PRELIM: 10919 Montrose Avenue R
Alterations & new addition
(Garrett Park Historic District)

Preliminary
Consultation # 2

PROPOSAL: Add rear addition; remove existing rear porch

DRAWING NUMBER: A2

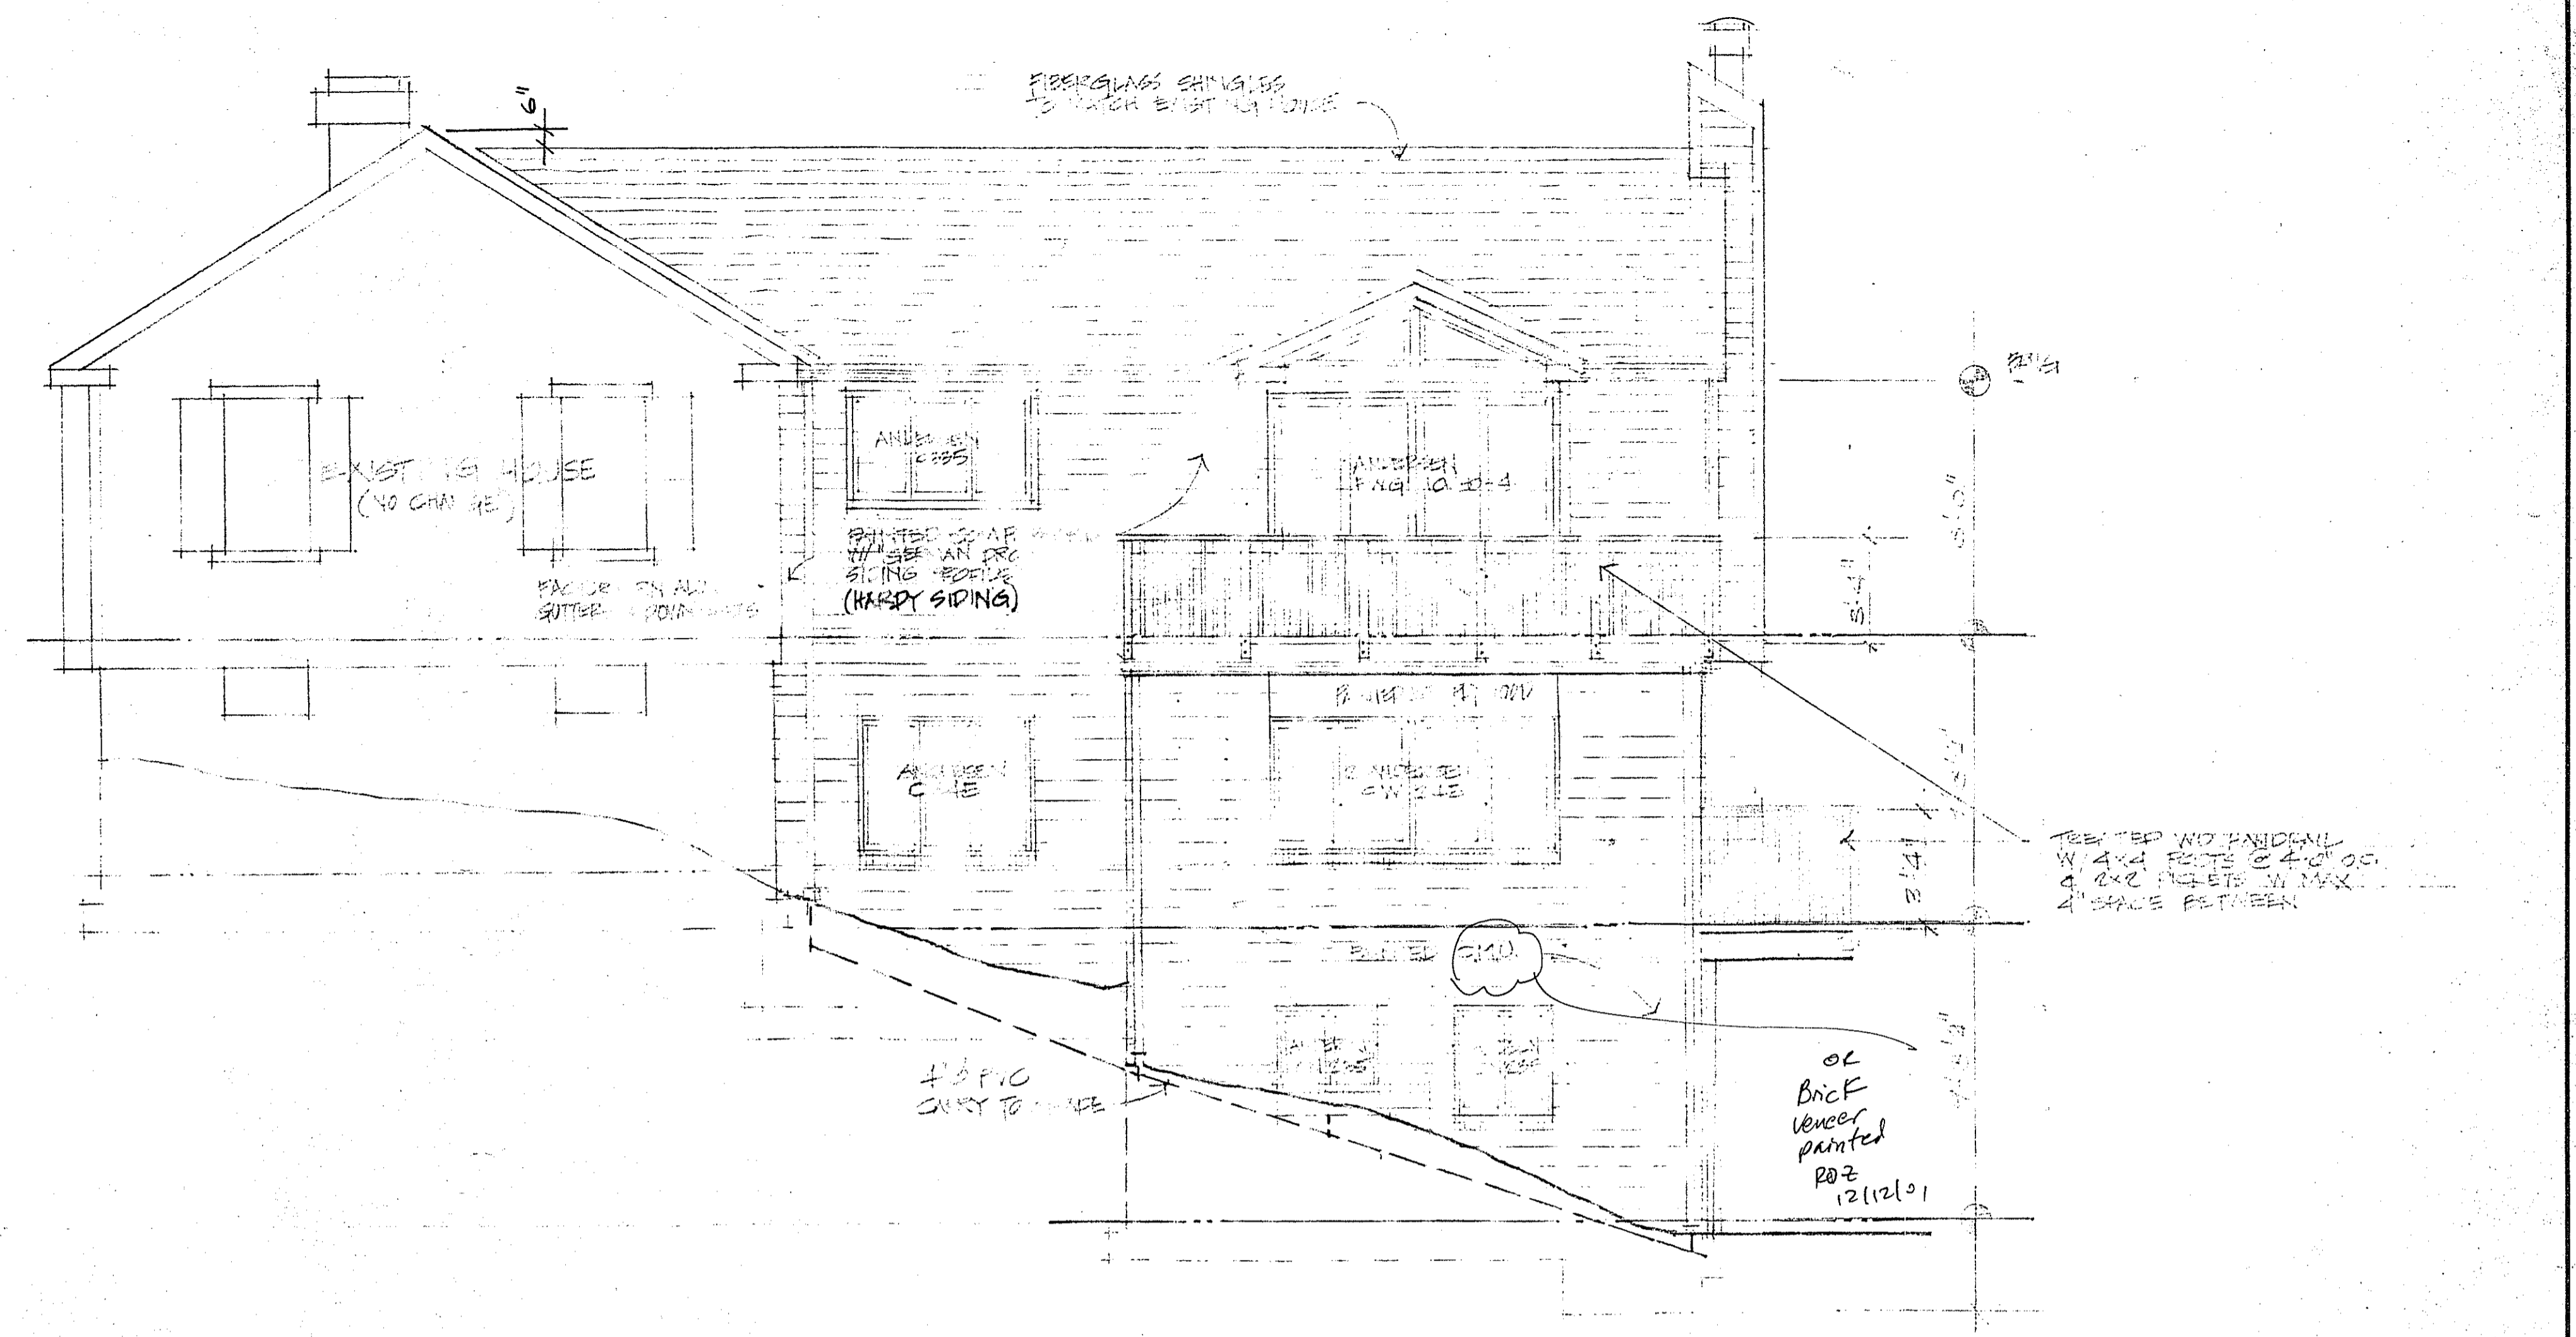
10/14/01 REVISE DIMENSIONS TO COMPLY WITH NEW CODES.
